ILC CFS AD&I Daresbury Lab

Summary

J.Osborne / V.Kuchler / A.Enomoto

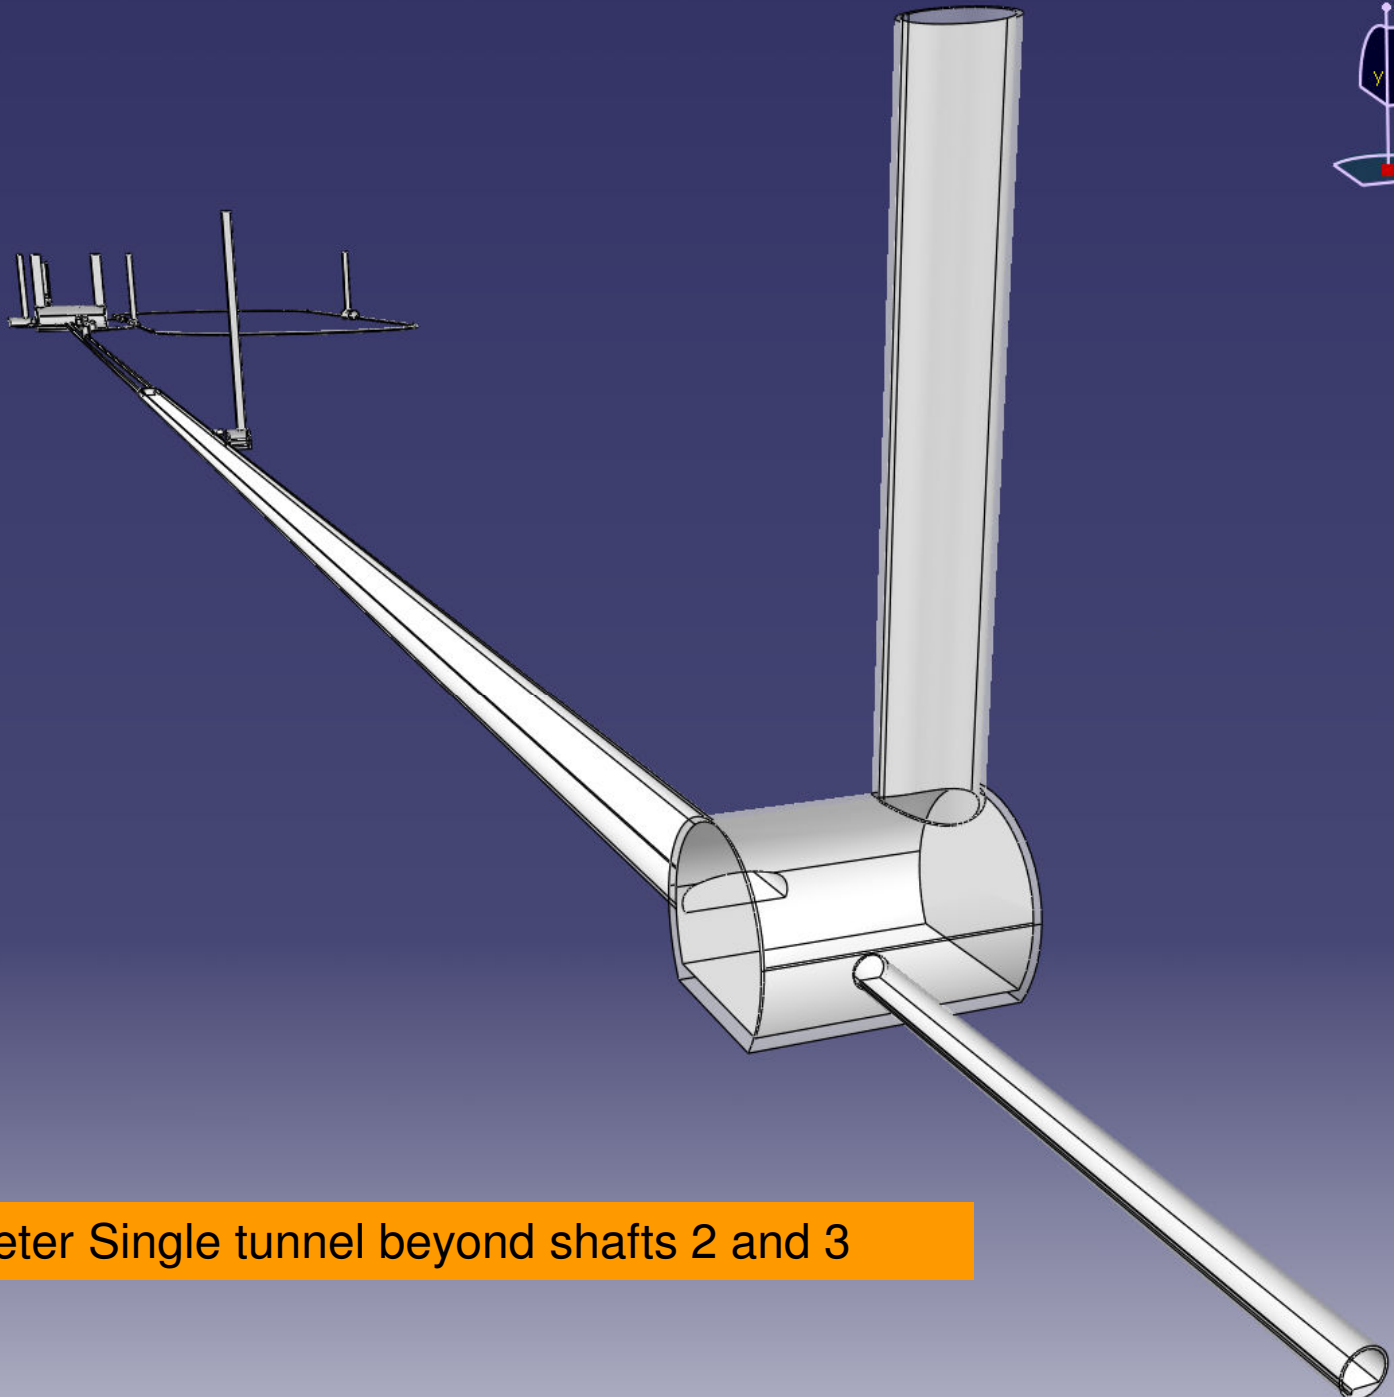
Beam dumps have been added (all cavern dimensions to be reviewed)

Interaction Region

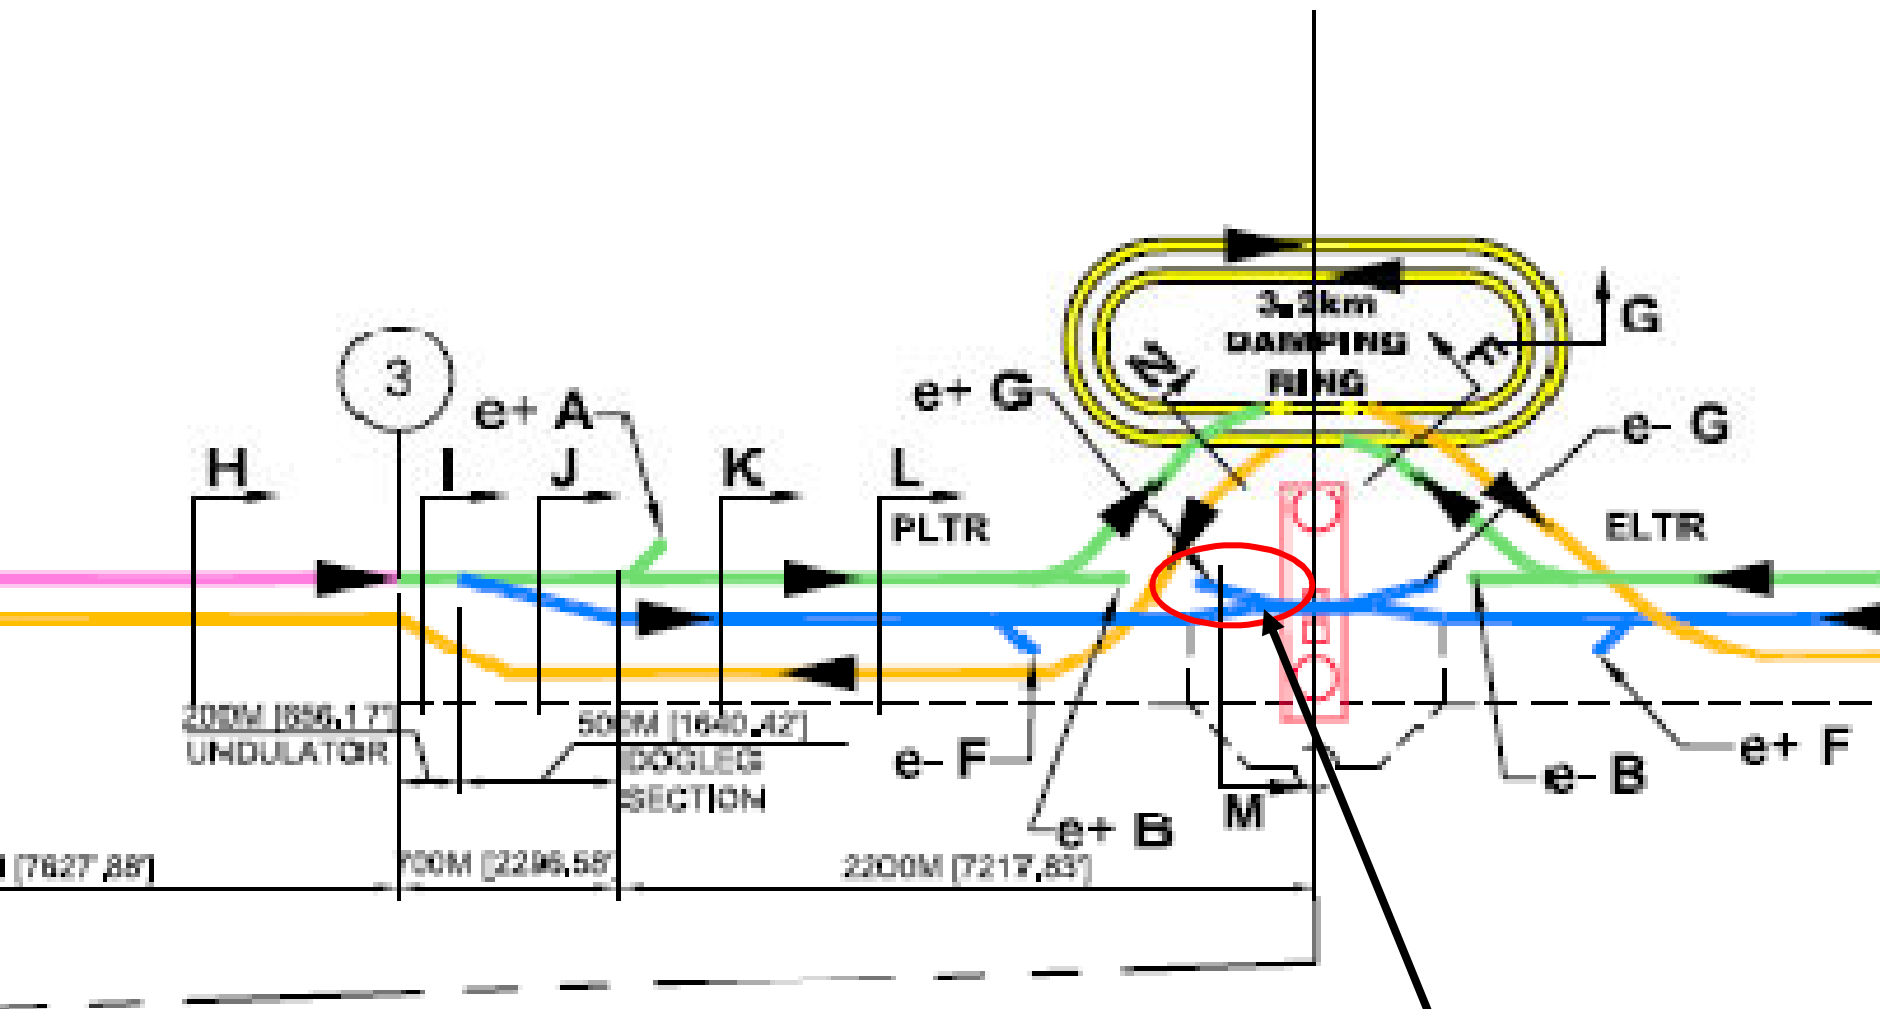
Main Beam dumps need to be moved to 'south side' i.e. opposite side of DR pointing downwards on this drawing.

This means, due to Muon radiation, level of service tunnel needs to be adjusted

Service tunnel revised layout – Dump is below service tunnel

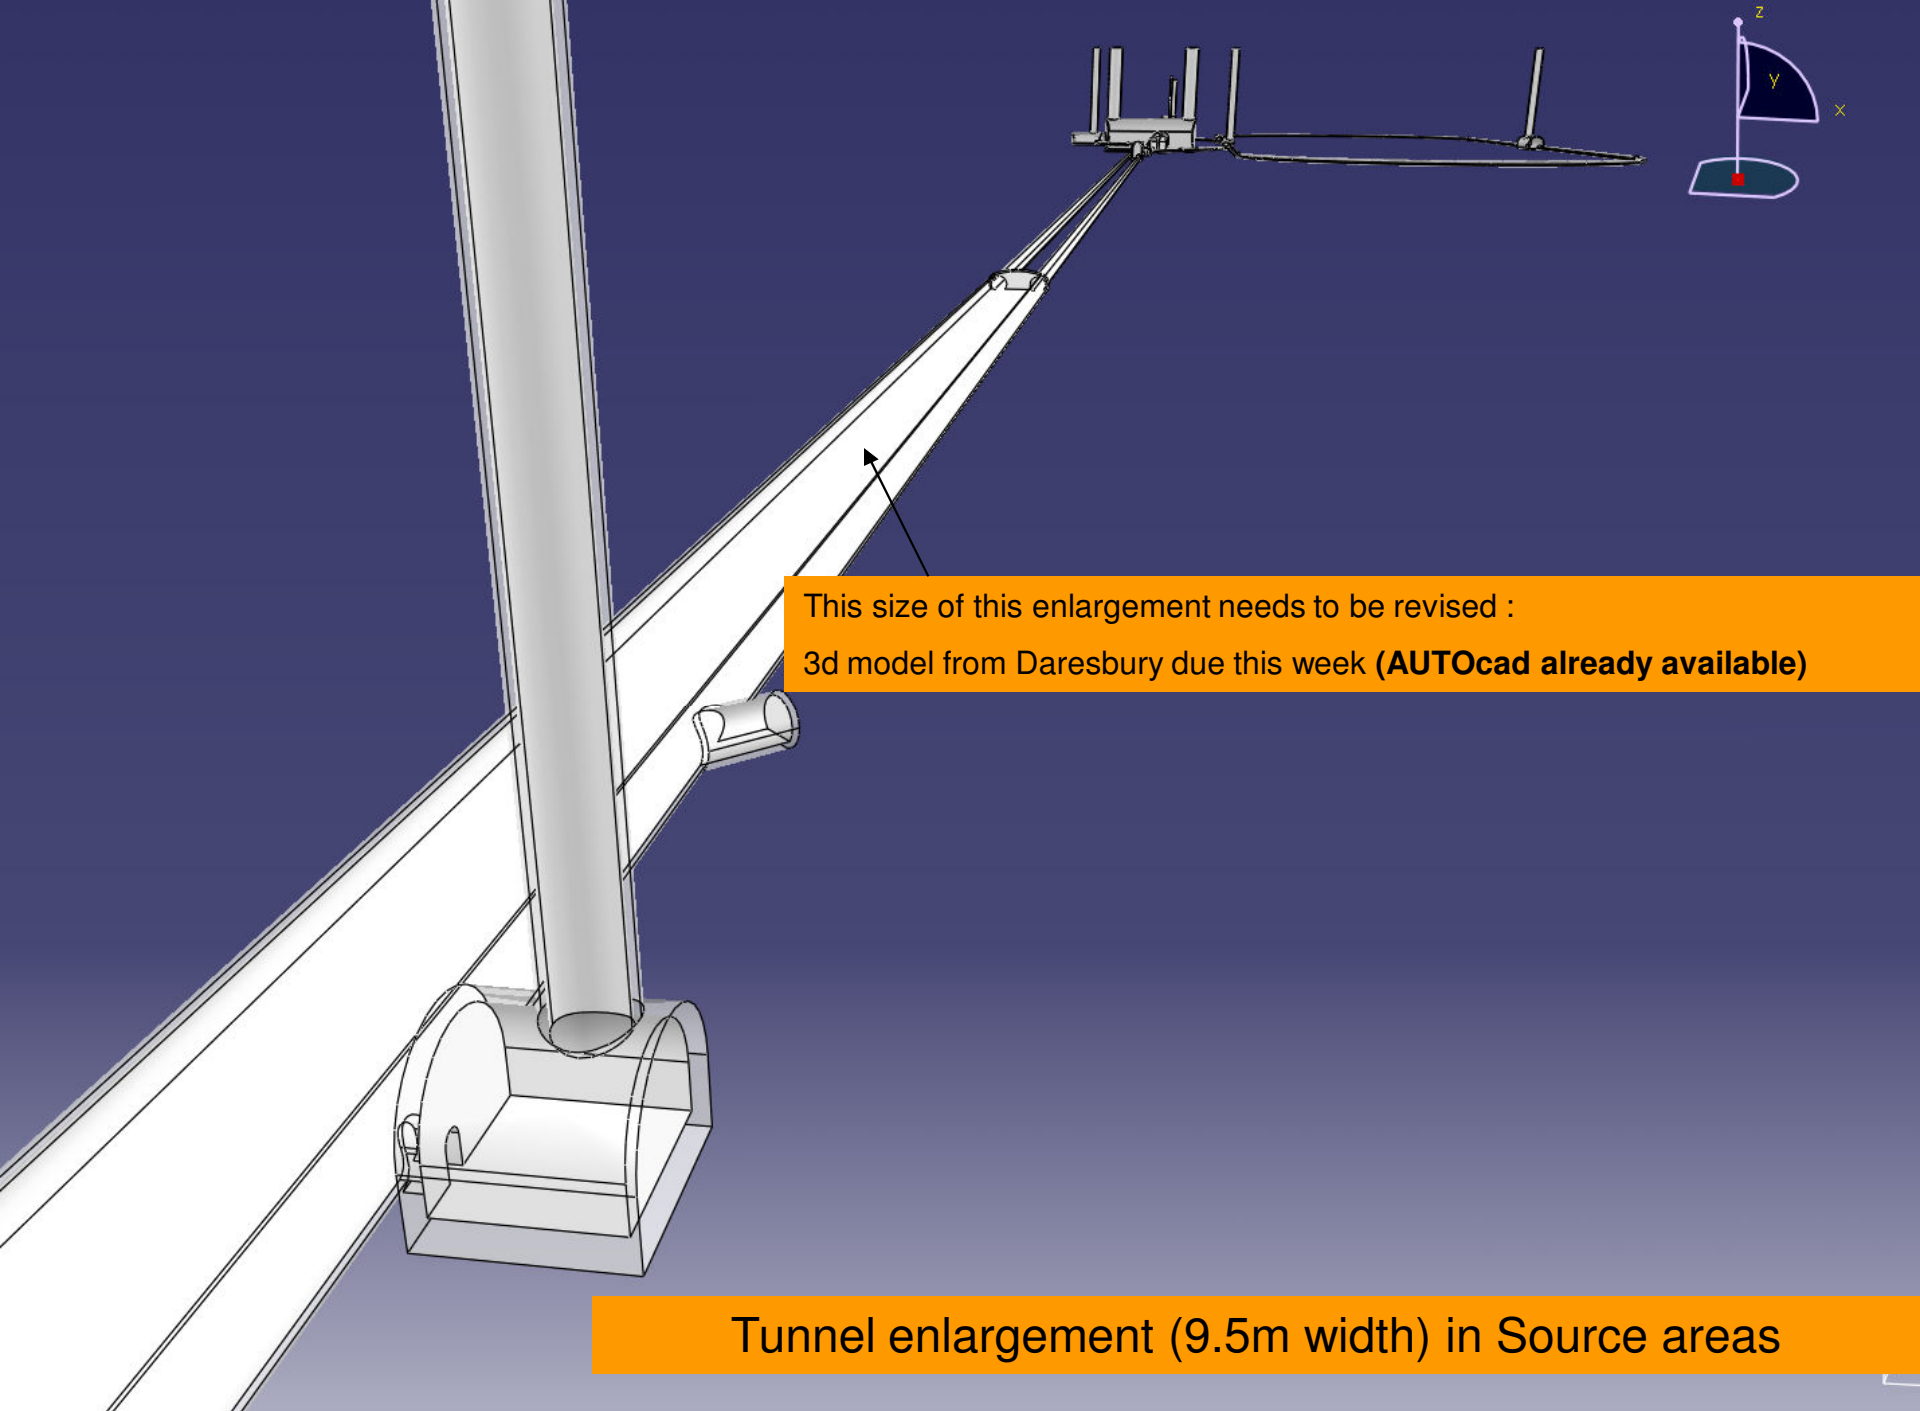
This size of this enlargement needs to be revised :
3d model from Daresbury due this week (**AUTOcad** already available)

SHEET - 2
Draft 8 28 09

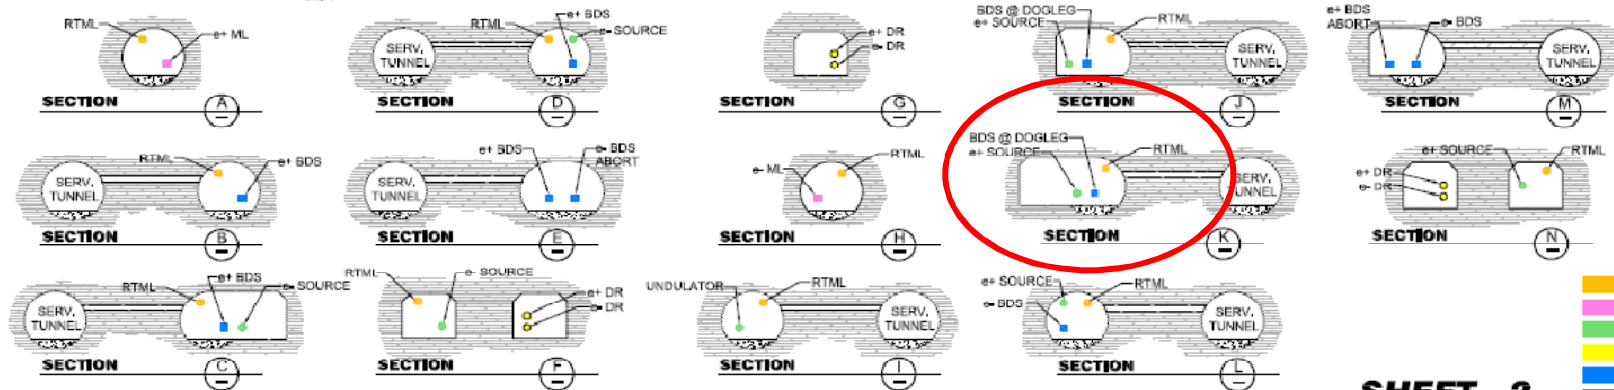
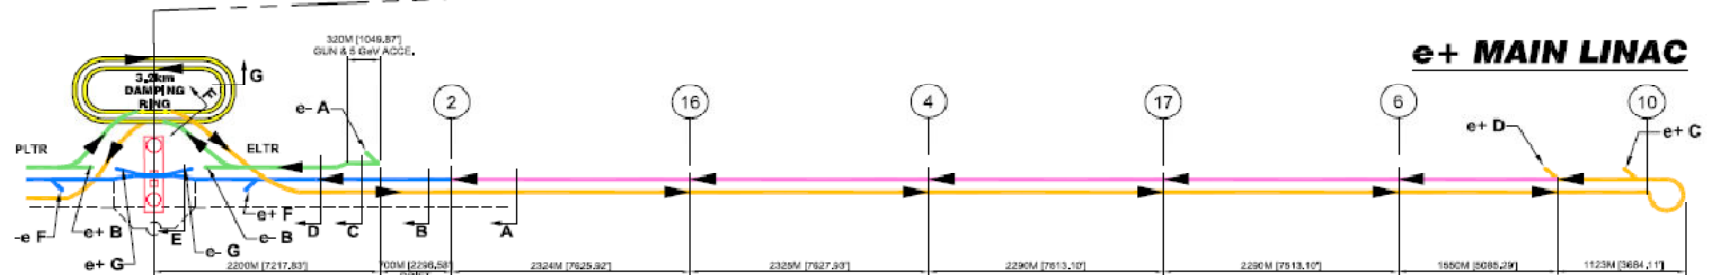
Tunnel enlargement (9.5m width) in Source areas needs to be reviewed (transport corridor on one side is acceptable?)

SECTION @ c- MAIN LINAC

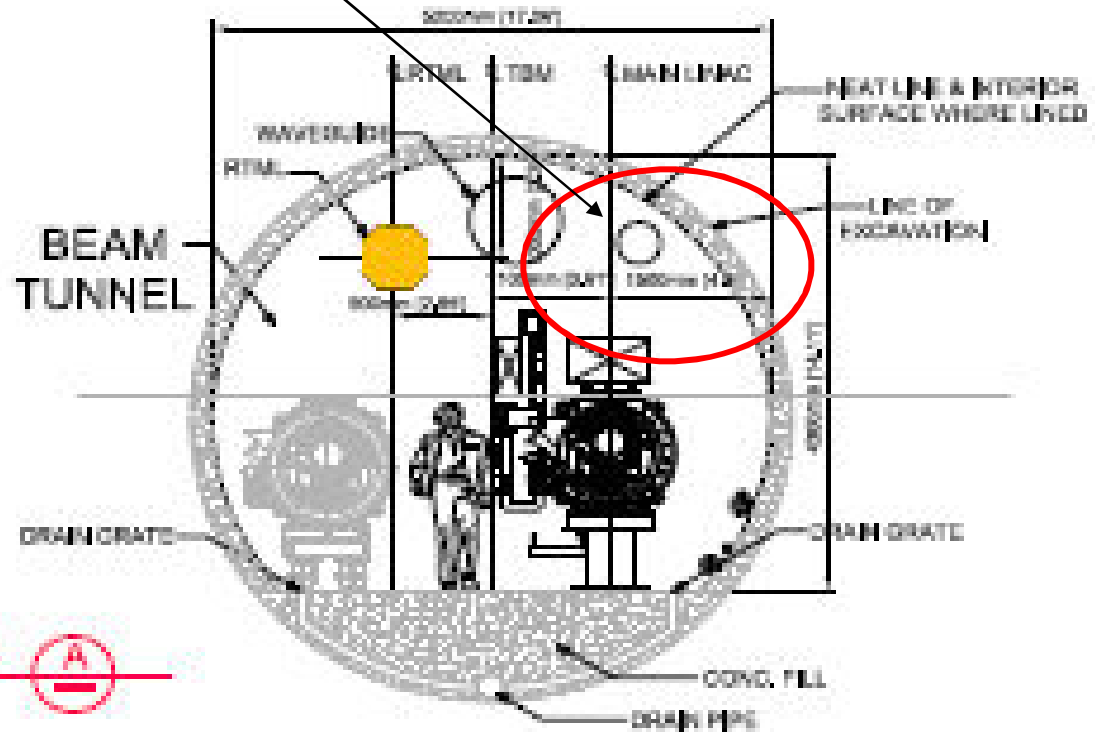
Is cryo vent pipe required in standard tunnel cross section ?
